## Addendum #1

Project Name: Toast Restaurant Expansion  
570 Fallbrook Boulevard, Suite 104, Lincoln, NE  
Project No.: 11077  
Issued: April 9, 2012  
Bid Date: 2:00 p.m., Tuesday, April 17, 2012  
Bid Opening: Bids will be privately opened

# Addendum 1

570 Fallbrook Blvd., Suite 104, Toast Restaurant Expansion

<b>570 FALLBROOK BLVD., SUITE 104 TOAST RESTURANT EXPANSION</b>			
PROJECT NO.	DATE	DRAWING REFERENCED:	M200
20112468	04-09-2012	ADDENDUM NO.:	1
			SKETCH <b>MS-1</b>

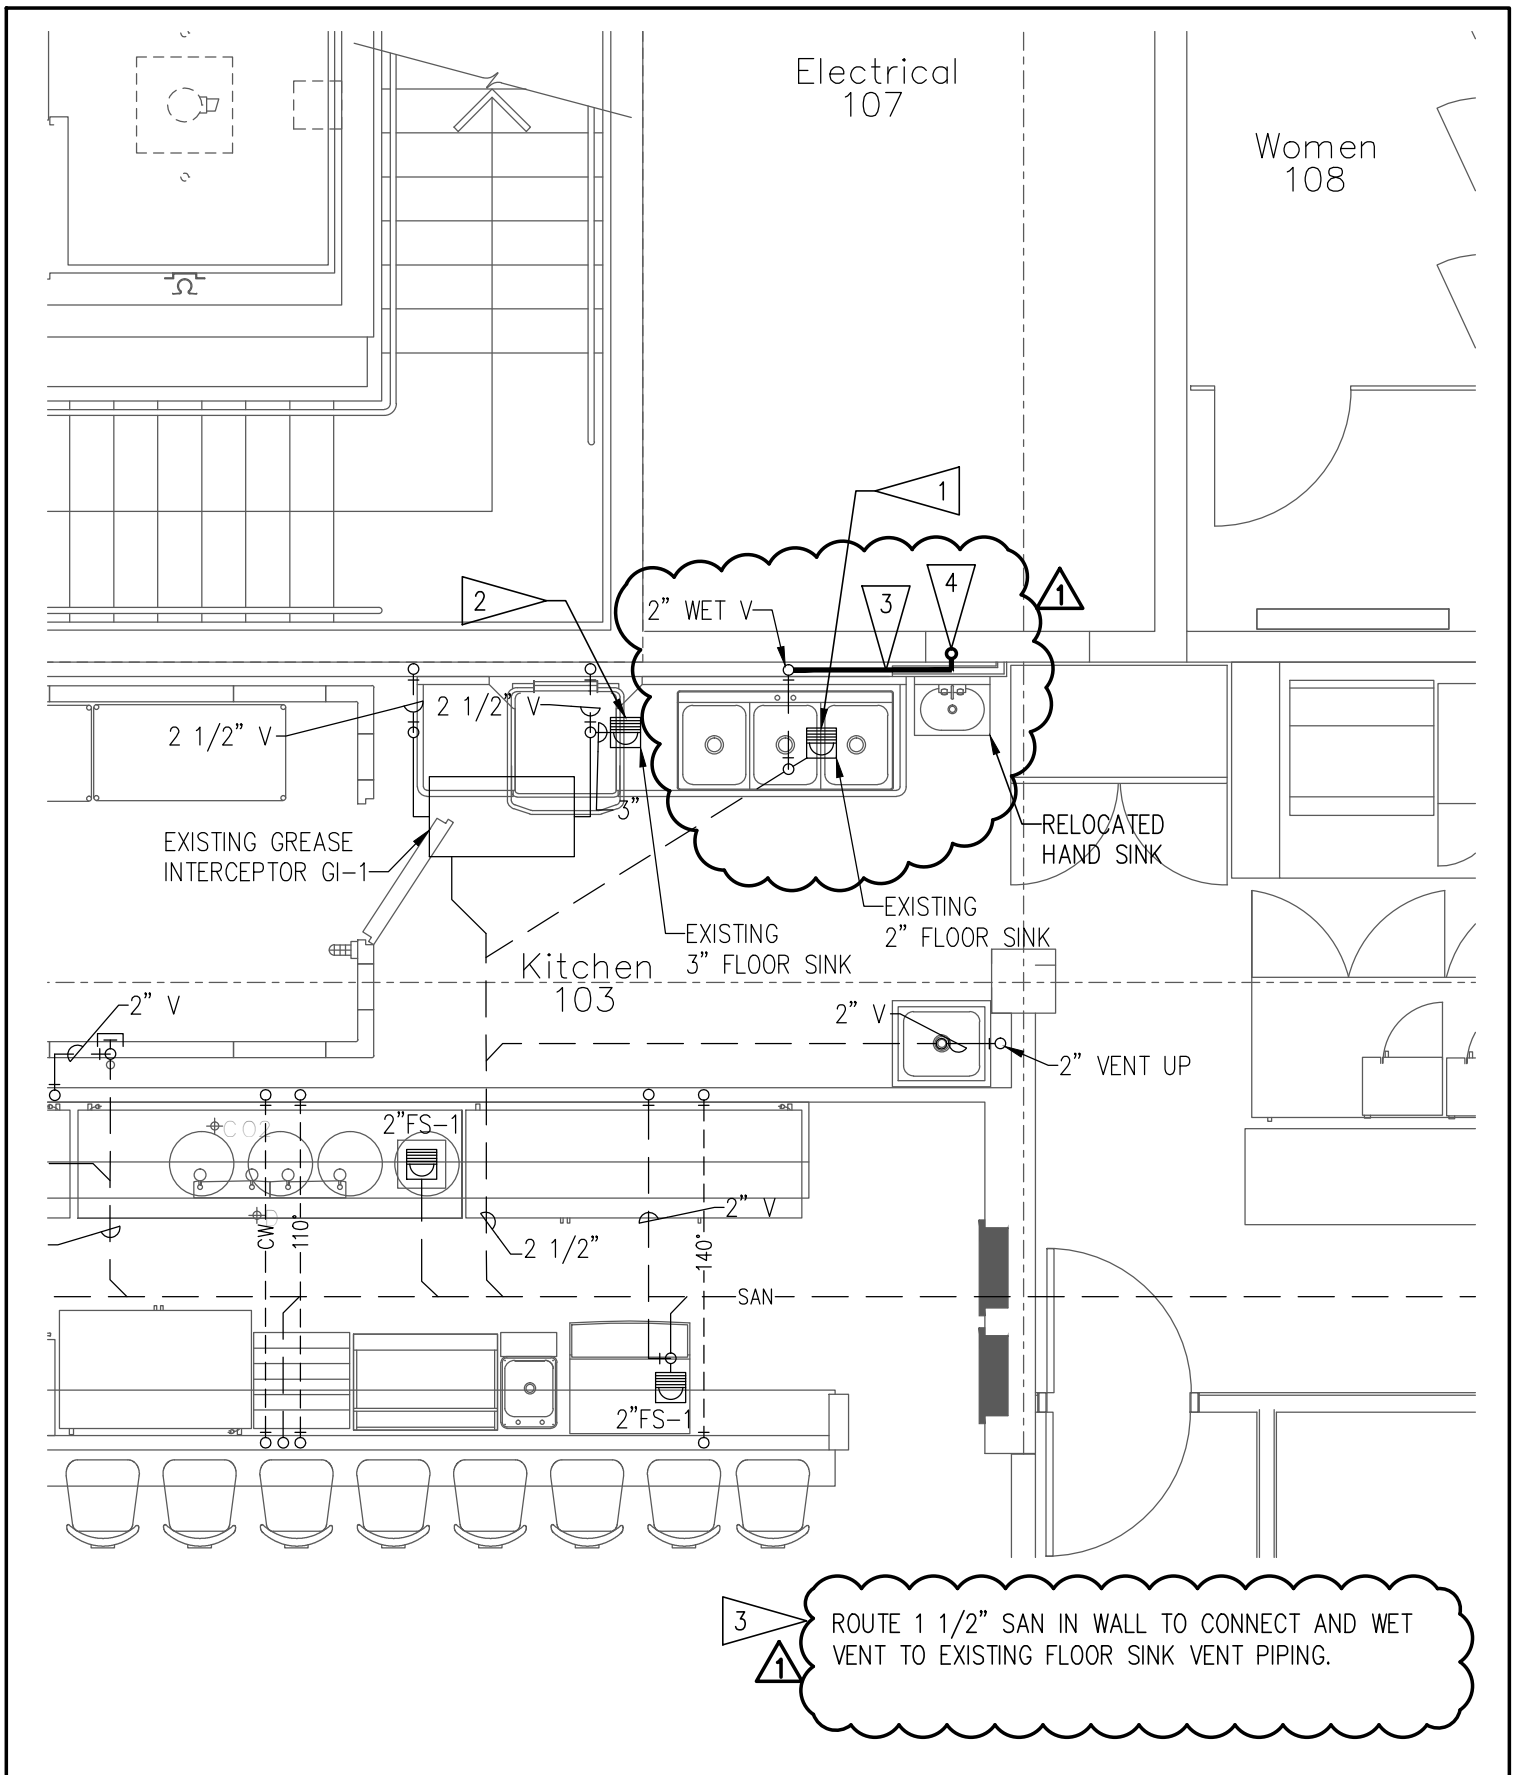
#### 1MD2. Sheet M200 – Under Floor Plan - Plumbing

1. The relocated hand sink shall drain to the nearby floor sink vent above floor to create a wet vent thus, eliminating the need to cut and patch the existing floor as indicated on attached Mechanical Sketch Sheet MS-1.
2. Revise Flag Note No. 3 as indicated on attached Mechanical Sketch Sheet MS-1.
